**RE: FTAA-2603-1185 HUNUA QUARRY DEVELOPMENT SUBSTANTIVE APPLICATION
LODGED UNDER FAST-TRACK APPROVALS ACT 2024 – UPDATES TO APPLICATION
FOLLOWING LODGEMENT**

1. The purpose of this letter is to provide an update to the Hunua Quarry Development proposal under the Fast-Track Approvals Act 2024 (FTAA) with regards to the following:
 - confirmation that the structure proposed to live the realignment channel is a weir, and to provide the relevant assessments; and
 - amend an error in the Part B – Assessment of Environmental Effects.

TO	Phil Heffernan	FROM	Verity Kirstein
	Winstone Aggregates	DATE	7 July 2026
RE	Stream Realignment – Enlivening Structure

FLOW MANAGEMENT WEIR				
SCALE :	DRAWING NO. :	REV :		
AS SHOWN (A3)	A035680017	A

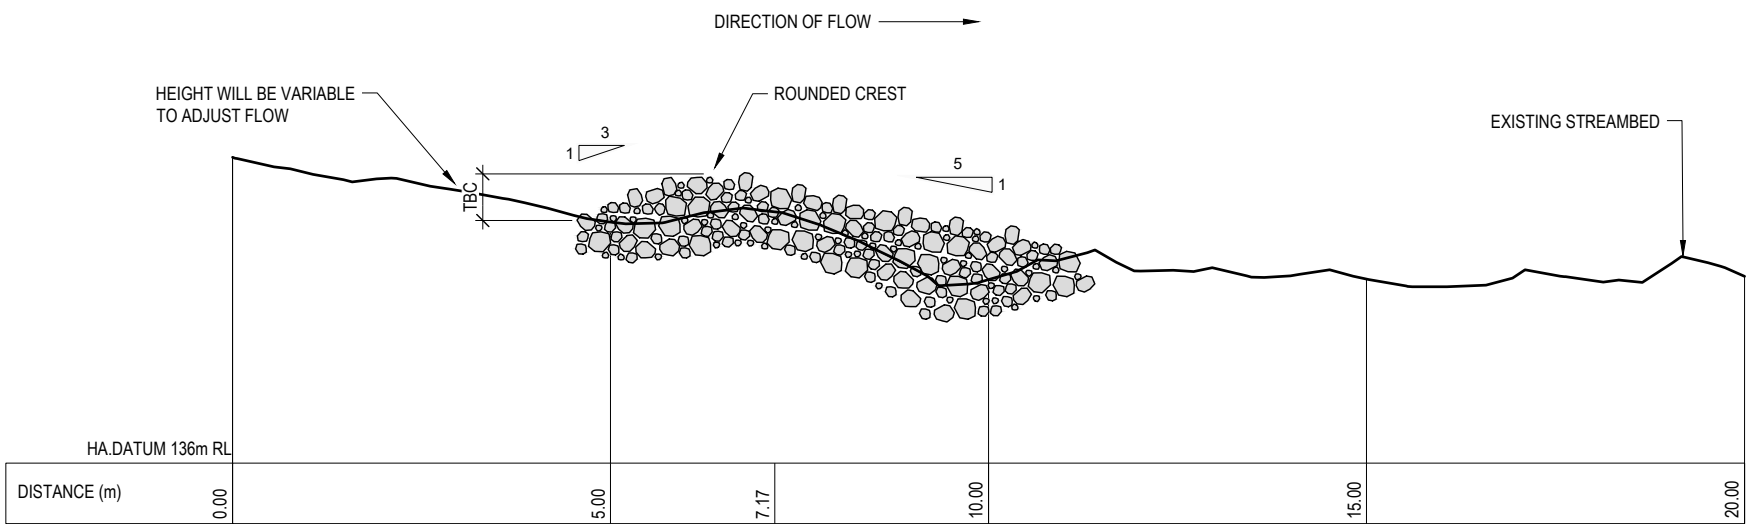
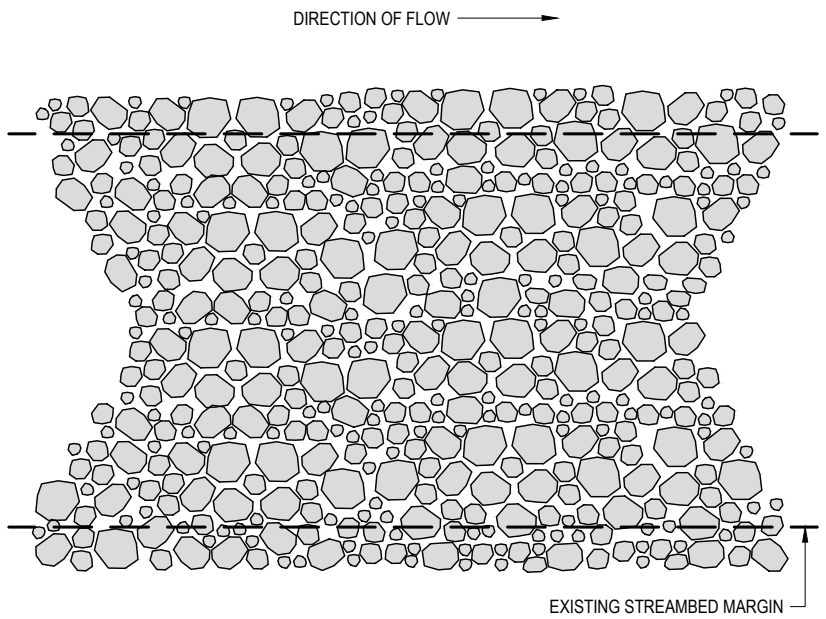
5. Following consultation with the Department of Conservation (DOC) regarding the stream realignment, further consideration of the design has identified that the materials will need to extend across the full width of the stream in order to minimise the risk of bank erosion.
6. Section 3 of the Resource Management (National Environmental Standards for Freshwater) Regulations 2020 ('NES-F') defines a weir to mean:

9. The PDP memo dated 7 July 2026 provides an overview of the weir including dimensions, design features and operation. The location of the weir within the tributary is yet to be determined, but as identified by PDP will be approximately 10m from the proposed diversion channel. The location of the weir will determine the final dimensions. However, it is anticipated that at the final phase of the staged diversion, the height could exceed 0.5m (potentially reaching up to 1m in height).

10. The design will maintain a continuous flow over surface of the weir (i.e., no perched flows), with design features such as a rounded crest, shallow downstream gradient and v-shaped profile to mimic the naturally occurring variable flow velocities. The slope of the weir will likely to be steeper than 1:30 (1:3 on the upstream slope and 1:5 on the downstream slope) due to the combination of the finished height and the limited natural channel shape and size.

At this stage the design has not been fully progressed to provide precise dimensions (which are location dependent), but it is anticipated that it will need to be several metres long to allow for a shallow slope on the downstream face. The longitudinal slope of the weir will likely to be steeper than 1:30 (the plans indicate 1:3 on the upstream slope and 1:5 on the downstream slope) due to the combination of the
